SUBJECT: ISSUANCE OF AMENDMENT FOR NINE MILE POINT NUCLEAR STATION UNIT NO. 2
(TAC NOS. 71519 AND 76399)

This amendment revises Technical Specification Section 3/4.4.6, Reactor Coolant System - Pressure/Temperature Limits, and the associated Bases. These changes are in accordance with Generic Letter 88-11.

Amendment No. 26
License No. NPF-69

SAFETY EVALUATION BY THE OFFICE OF NUCLEAR REACTOR REGULATION
RELATED TO AMENDMENT NO. 26 TO FACILITY OPERATING LICENSE NO. NPF-69
NIAGARA MOHAWK POWER CORPORATION
NINE MILE POINT NUCLEAR POWER STATION, UNIT NO. 2
DOCKET NO. 50-410

FIGURE 3.4.6.1-1

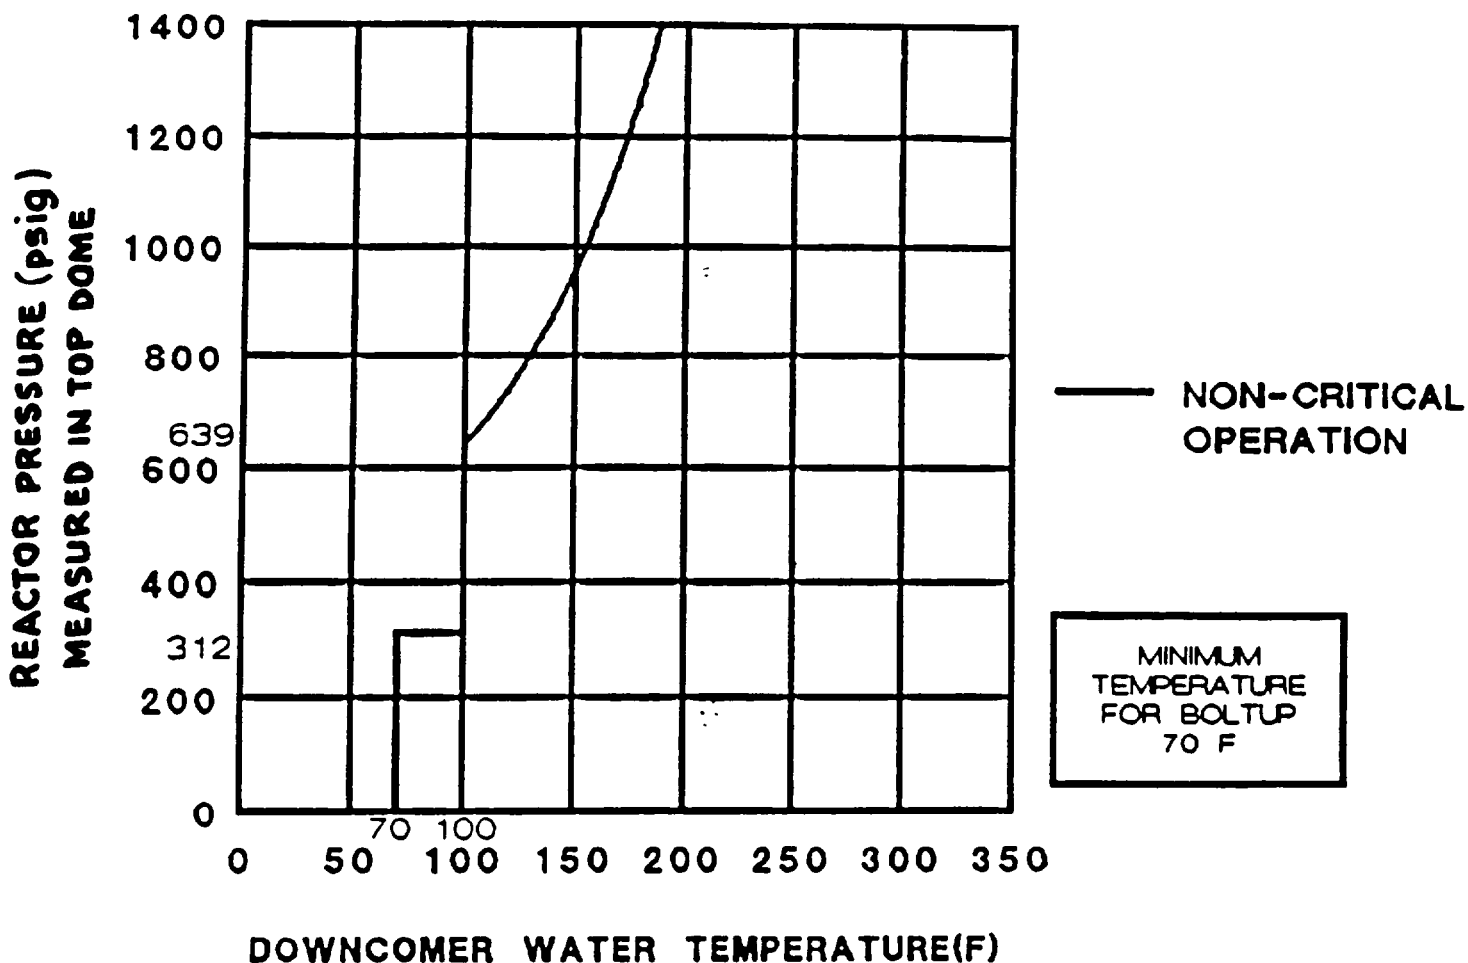
3.4.6.1 The reactor coolant system temperature and pressure shall be limited in accordance with the limit lines shown on Figure 3.4.6.1-1 for hydrostatic or leak testing; Figure 3.4.6.1-2 for heatup by non-nuclear means, Figure 3.4.6.1-3 for cooldown following a nuclear shutdown and low-power PHYSICS TESTS; and Figures 3.4.6.1-4 and 3.4.6.1-5 for operations with a critical core other than low-power PHYSICS TESTS, with:

MINIMUM BELTLINE DOWNCOMER WATER TEMPERATURE FOR PRESSURIZATION DURING IN-SERVICE HYDROSTATIC TESTING AND LEAK TESTING (REACTOR NOT CRITICAL) FOR UP TO 12.8 EFFECTIVE FULL POWER YEARS OF OPERATION

FIGURE 3.4.6.1-4 MINIMUM BELTLINE DOWNCOMER WATER TEMPERATURE FOR PRESSURIZATION DURING CORE OPERATION (CORE CRITICAL) (HEATUP AT A HEATING RATE \leq 100 F/HR) FOR UP TO 12.8 EFFECTIVE FULL POWER YEARS OF OPERATION

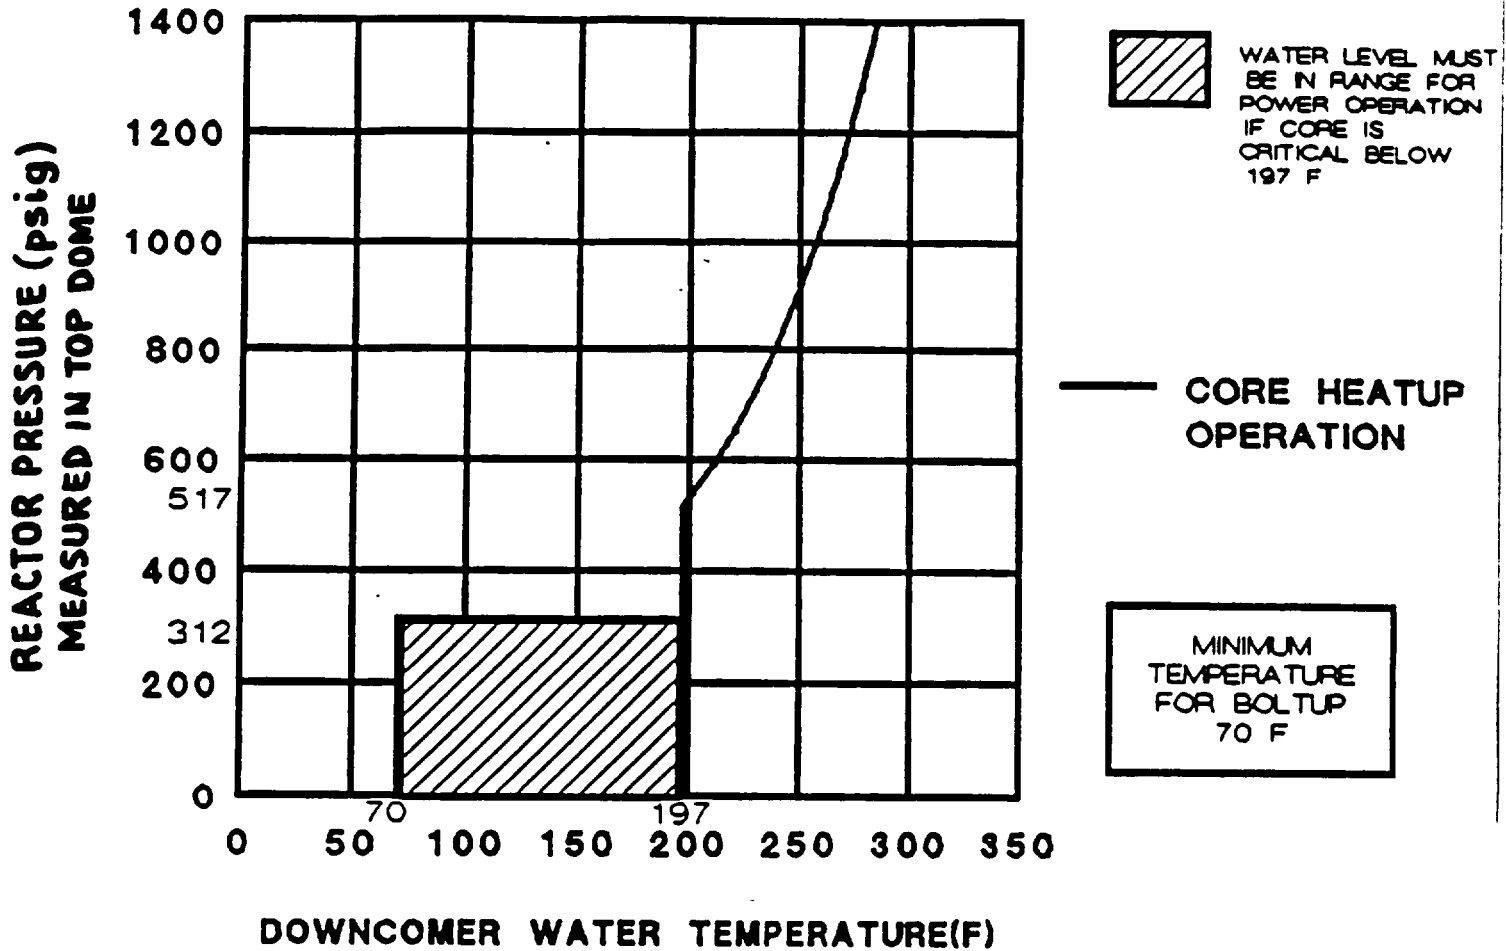
Provided the water level is in the range for power operation, the core may be critical when left of the criticality limit line if the pressure is maintained below 312 psig (see cross-hatched region in Figures 3.4.6.1-4 and 3.4.6.1-5). In this case, the reactor coolant temperature and pressure shall be determined to be within the cross-hatched region of figures 3.4.6.1-4 and 3.4.6.1-5 within 15 minutes before withdrawal of control rods to bring the reactor to criticality and at least once per 30 minutes during system heatup.
